HISTORIC PRESERVATION COMMISSION MEETING

1. Case COA24-20: Request for exterior alteration at 418 West 7th Street. The Paul and Mina Jannssen House is located within the Hamburg Local Landmark Historic District. Matthew Bevirt, petitioner. [Ward 3]

Case COA24-20: Request for exterior alteration at 418 West 7th Street. The Paul and Mina Jannssen House is located within the Hamburg Local Landmark Historic District. Matthew Bevirt, petitioner. [Ward 3]

Re: Historic Preservation Commission Review Determination – Case COA24-20

1.REMOVE EXTERIOR STAIRWAY; BUILD 8' X 16' DECK

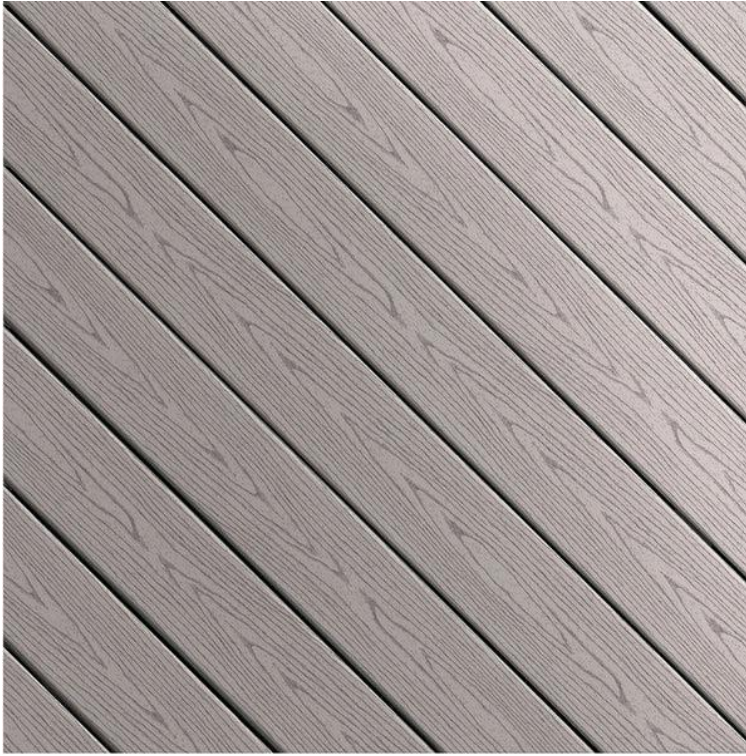
According to a permit on file with the Building Department, the existing exterior staircase in the rear of the home was constructed in 2003. This was a replacement staircase. Staff believe an exterior staircase was added when the residence was converted into four apartment units. Since there is no longer an apartment unit on the upper floor, this staircase is no longer required per building and fire code. The existing staircase holds no historical merit. Therefore, staff do not object to its removal.

Following the demolition of the existing staircase, the homeowner intends to construct a new 8' x 16' composite deck and staircase, extending from the first floor to ground level. While the design will have less of a vertical impact on the home's rear elevation, it will project further from the facade and into the rear yard. The proposed materials are composite deck boards and aluminum railings. While these are modern materials, the Commission has approved composite decking on other porches in the Hamburg District.

ALTERNATIVE DESIGN NORTH FAÇADE

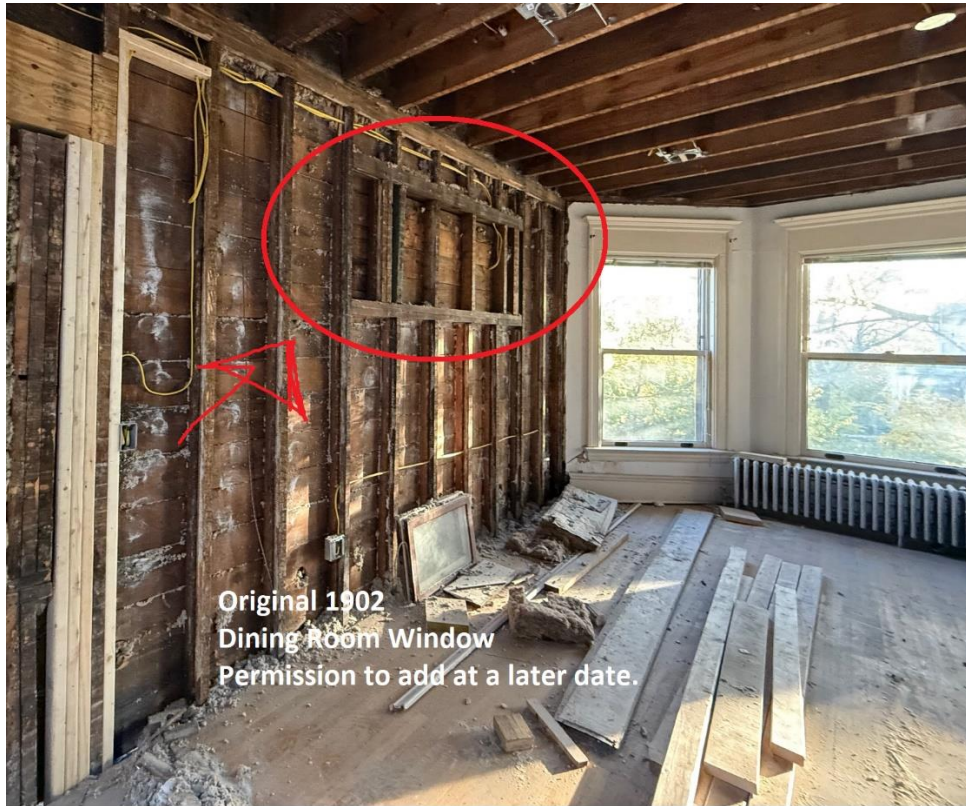
Double French door DOES NOT balance out mass, scale, overall aesthetic and look of exterior north façade alley facing rear of property.

**2. REMOVE FIRST FLOOR NON-ORIGINAL KITCHEN DOOR & WINDOW NORTH ALLEY FACING REAR
REPLACE WITH NEW MARVIN HISTORICAL DOOR**

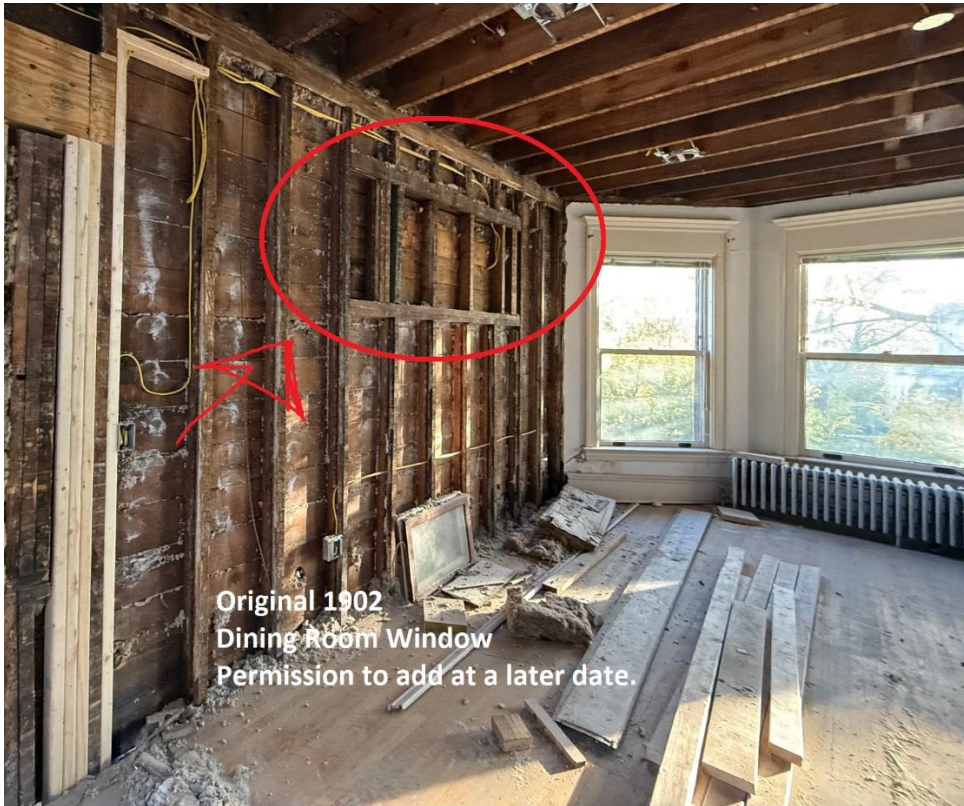
The applicant intends to remove and replace the rear door and window with a 12' wide by 7' tall Marvin sliding glass door. The replacement sliding glass doors will have a wood interior and fiberglass exterior. The owner's intent is to match the aesthetic with the front-facing living room windows by incorporating both Craftsman and Queen Anne features. However, images of the front living windows were not provided in the application. It is unclear the extent that the sliding glass doors replicate the front windows. The proportions of the trim will match the balance of the home's exterior. Staff generally do not discourage new additions. However, the design must be compatible with the size, massing, scale, color, materials, and character of the property. The combination of a large composite deck and modern sliding glass doors is inconsistent with the overall aesthetic of the 1902 home.
